Job Ref: 17013

RMA20180414 | 174-176 BROOKVALE ROAD, HASTING | RESPONSE TO FURTHER INFORMATION

The following is our response to the matters raised in the letter dated 7 June 2019 seeking further information.

Pond Calculator

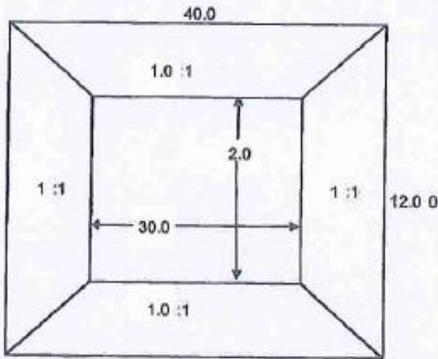
3. *The response to the further information request (dated 5 February 2019) advised that the volume of earthworks associated with constructing the oxidation pond was approximately 500m³ and the depth of the excavation was approximately 3m. By our estimate, it appears that the length of the pond is approximately 39m and the width is approximately 14.5m. If that is correct, we anticipate that the volume of earthworks to construct the pond would have been approximately 1,696m³. Please advise how the 500m³ volume of earthworks was calculated.*

A volume of 1,696m³ comes about by assuming a uniform rectangular pond i.e. 39m long x 14.5m wide x 3m deep = 1,696m³. With batters along each side however, the shape of the pond is not a uniform rectangle and the volume of earthworks is subsequently much less.

We have since been provided with a pond calculator prepared for the installation of the liner (refer **Attachment 1**). This indicates an excavation depth of 5m and an excavation volume of 1,225m³. We are advised however that the actual excavation was much less – at approximately 3m deep, with a 0.5m high bund formed above the surface to provide an overall vertical extent of 3.5m deep within which the pond was formed. Although exact calculations are not available, the volume of earthworks to construct the pond is expected to have been in the order of 650m³-1,000m³.
